SUBJECT: Forwards responses to NRC open items & questions identified in 801107 ltr re staffing, sys & effluent parameter values; source term & magnitude of radioactive releases, sprinkler sys, methodology for determining doses & monitoring readings.

Subject: Docket Nos. 50-361 and 50-362
San Onofre Nuclear Generating Station
Units 2 and 3

Enclosure 2

Response to NRC Questions

FIGURE 432.42-1

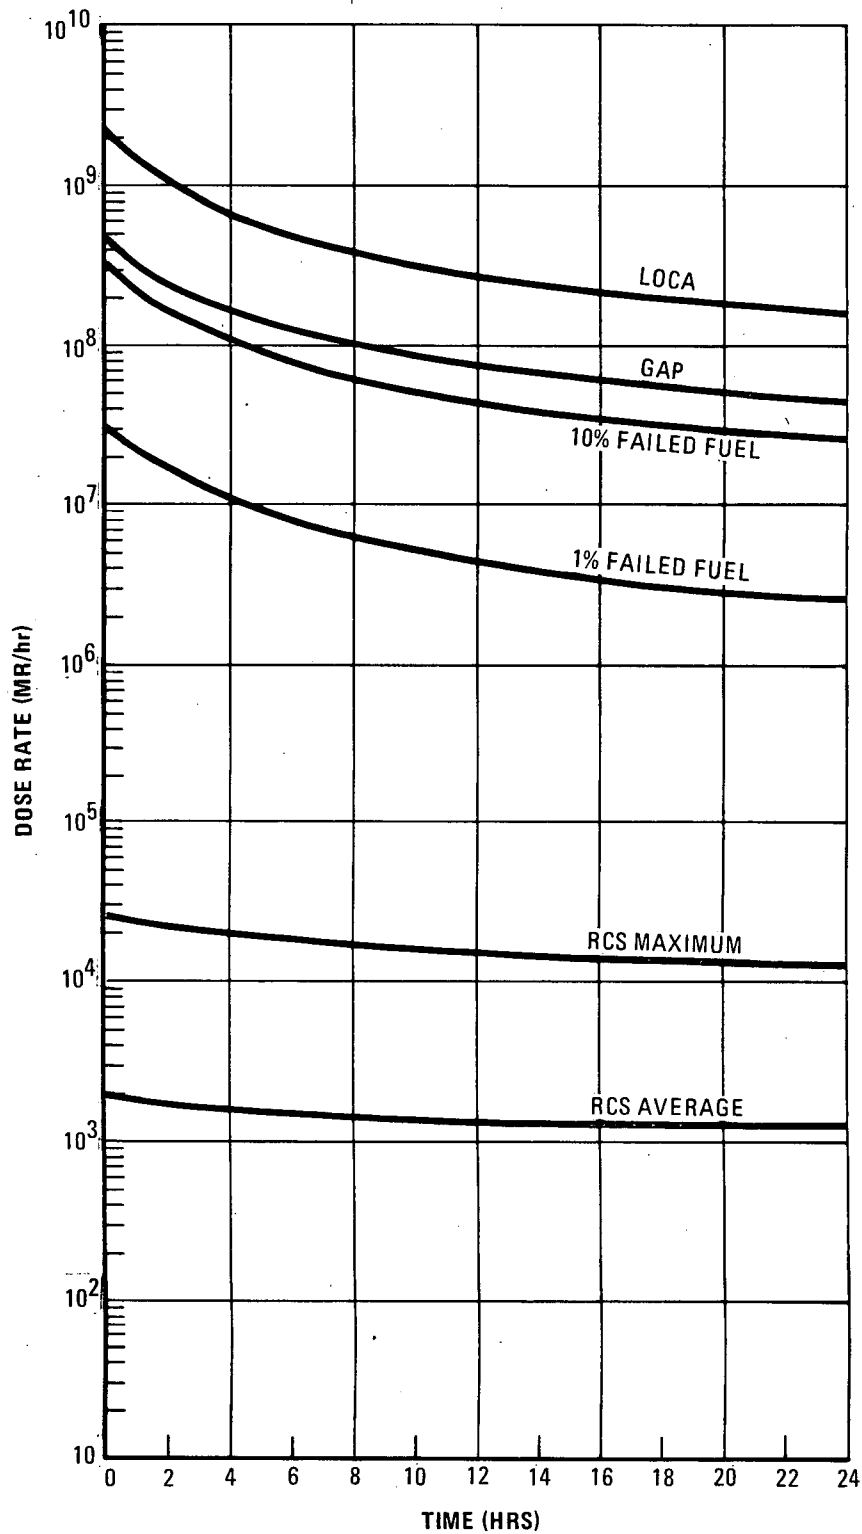
Question 432.42

Establish the relationship between effluent monitor readings and onsite and offsite exposures and contamination for various meteorological conditions.

To evaluate the onsite exposure due to large radioactive releases within the containment, the dose is determined using readings from the high range in containment monitors and emergency radiation monitoring system detectors and preestablished relationships (see figures 432.42-1, 2, and 3).
